Product Change Notification

Change Notification #: 109220 - 00
Change Title: 41110 and 41210 Serial-to-Parallel PCI Bridge, PCN 109220-00, Transport Media, Tray Design
Date of Publication: March 13, 2009

Transport Media

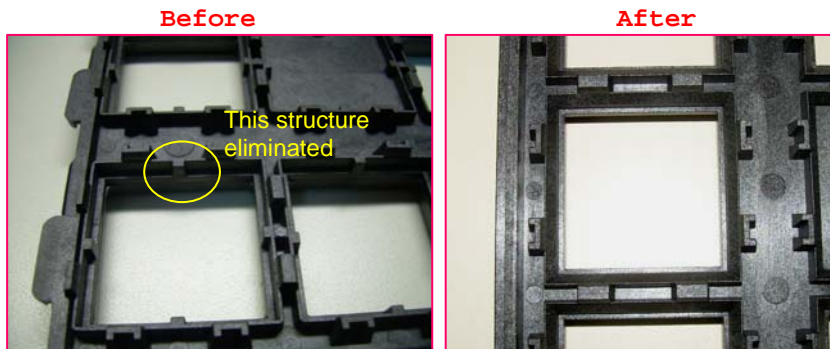
In order to avoid ball damage issues from mis-orientation, Intel has made a slight design change to the shipping tray for the products listed below. The new tray will eliminate the mid-span structure to provide better protection to units. The tray material changed from - Modified Poly Sulfone (MPSU) to Modified Polyphenylene oxide (MPP0) for better mechanical strength. There is no change to critical for Function (CTF) dimensions or to outer dimensions of the tray. There is no change to the unit seating locations or to the tray to tray stacking.

See diagram below:
